Access Compliance Report

Public Rights-of-Way

(Curb Ramps)

Intersection ID: 6690	Main Street: NEVIN_RD	Cross Street: SPRING_TERRACE_LN	Location: W
ADA ID: D120BD1BB124	Ramp Type: Directional1	Initial Pass/Fail: Pass	Overall Compliance: No
		Severity Score: 2.75	
Codes/Mitigation Info/Possible Solution		Field Measurements/Component Compliance

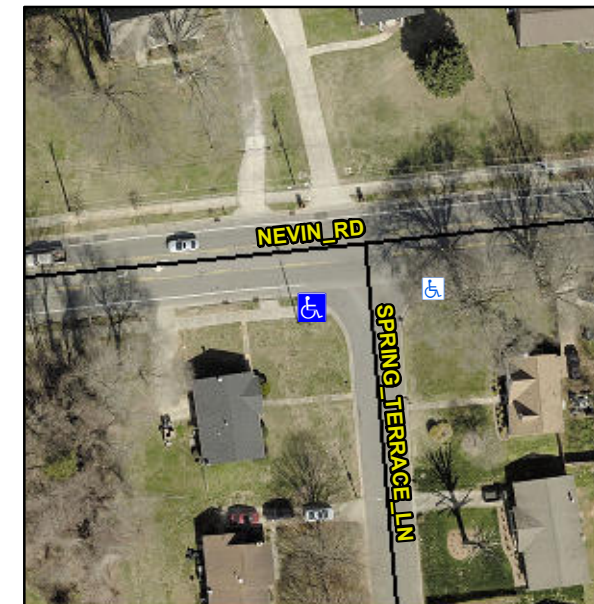
R304.5.3, R305.1.4, R305.2

Compliance	Description	Data	Compliance	Description	Data
N/A	Ramp Length (in)	58.0	Yes	Grade Break?	Yes
Yes	Ramp Width (in)	68.0	No	Grade Break Slope (%)	6.6
Yes	Ramp Slope (%)	7.8	Yes	Grade Break XSlope (%)	1.5
No	Ramp XSlope (%)	2.2			
Yes	Flare Type LT	N/A	Yes	Flare Type RT	N/A
N/A	Flare Slope LT (%)	N/A	N/A	Flare Slope RT (%)	N/A
N/A	Flare Traversable LT?	No	N/A	Flare Traversable RT?	No
Yes	Landing Length (in)	48.0	Yes	DWS Provided?	Yes
Yes	Landing Width (in)	71.0	Yes	DWS Contrast?	Yes
Yes	Landing Slope (%)	1.4	Yes	DWS Length (in)	24.0
Yes	Landing X Slope (%)	0.5	No	DWS Full Width?	No
N/A	Landing Curb? (Y/N)	N/A	Yes	DWS Offset LT (in)	58.5
N/A	Shared Landing?	No	No	DWS Offset RT (in)	9.5
Yes	Gutter Ponding?	No	Yes	Gutter Slope (%)	0.5
Yes	Gutter Lip Ht (in)	0.0	No	Gutter X Slope (%)	2.6
N/A	Painted X Walk1?	No		Road Slope (%)	0.1
	X Walk 1 Direction	To E		Road X Slope (%)	1.9
	X Walk 1 Width (in)	N/A		Clear Space?	Yes

X Walk 1 Slope (%)	0.1	N/A	Clear Space to XWalk (in)	N/A
	X Walk 1 X Slope (%)	1.9	Yes	Storm Grate/Utility Hazard?	No
N/A	Ramp inside XWalk1?	N/A		Storm Grate/Utility Type	
Yes	Any Obstructions?	No			N/A
	Obstruction Type		Yes	Surface Condition? (G/P)	Good
			N/A	Curb Slope (%)	15.3

**Remove & Replace Entire Ramp.
Remove & Replace Gutter.**
